# PROPOSED INDUSTRIAL DEVELOPMENT

## STAGE 1 - 117 SOMERSET ROAD

## Engineering Assessment Report

**Project Number:** 24-126  
**Client:** Hollywood Earthmoving Pty Ltd  
**Site:** 117 Somerset Road, Gracemere QLD, Australia  
**Scope:** Condition Report

Figure 2 - Revised location of Proposed Shed

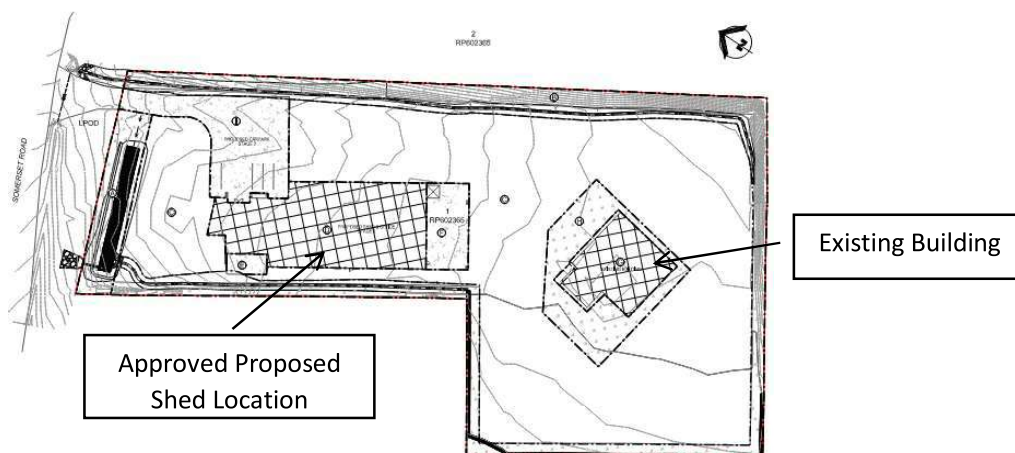
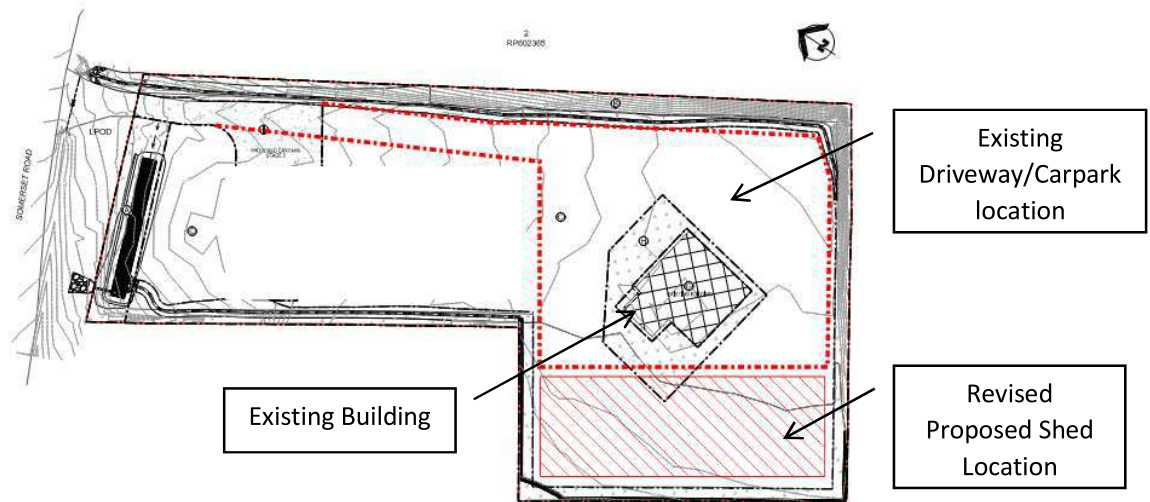
The subject site consists of an area of 10,610 m<sup>2</sup> at Lot 1 on RP602365; Figures 1 and 2 below show the approved and revised location of the proposed shed.

The proposed development will utilise the stormwater management plan previously approved by the council. The location of the proposed shed has been shifted from the front to the rear of the property. The Rational Method has been employed to determine the flow rates on and through the subject site, which remain consistent in the revised post-development scenario. Ground level and roof runoff from the revised shed location will be directed to an existing kerb on Somerset Road via a series of vegetated swales and the bio-retention basin.

The detention volume for the project has been increased with the volume previously approved by the council from 60m<sup>3</sup> to 90m<sup>3</sup> due to the increase in the sealed driveway area. The locations of the bio-retention basin, as well as the vegetated swales A and B along the eastern and western boundaries, will remain unchanged. For further details, please refer to Appendix B, which contains the stormwater quantity assessment.

Figure 5 - Stormwater Quality Treatment Train

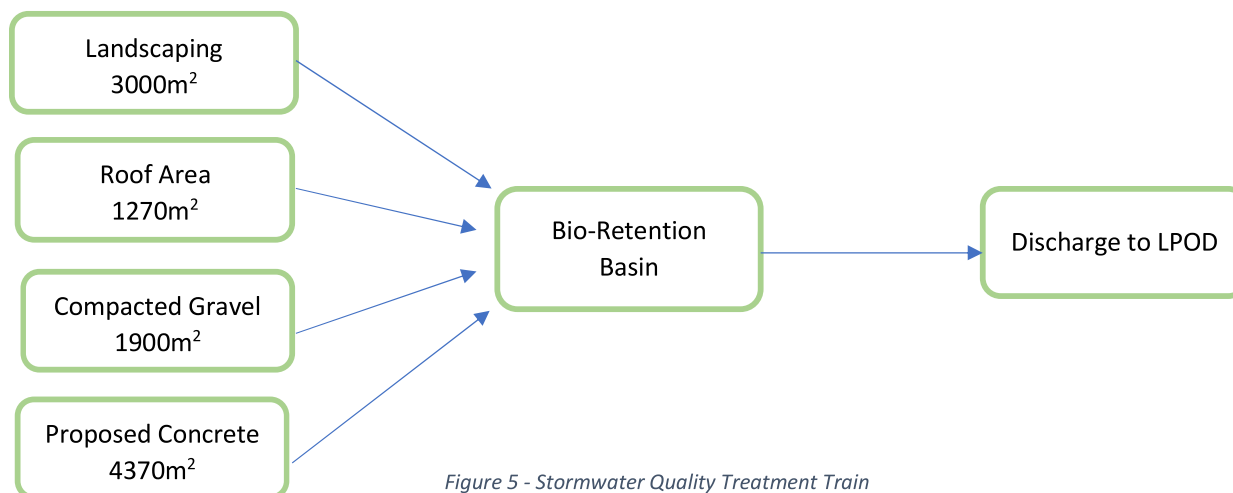
The proposed will reduce the amount of sediments and nutrients discharged from the proposed development. The previously approved concrete area of 808 m<sup>2</sup> has been increased to 4370 m<sup>2</sup> and the compacted gravel area has been reduced to 1900 m<sup>2</sup>. The roughness coefficient for both the concrete and compacted gravel surfaces is the same, ensuring that this change will not affect the discharge to the bio-retention basin. The design assumes a 100% impervious fraction for the concrete surface and a 50% impervious fraction for the compacted gravel area.
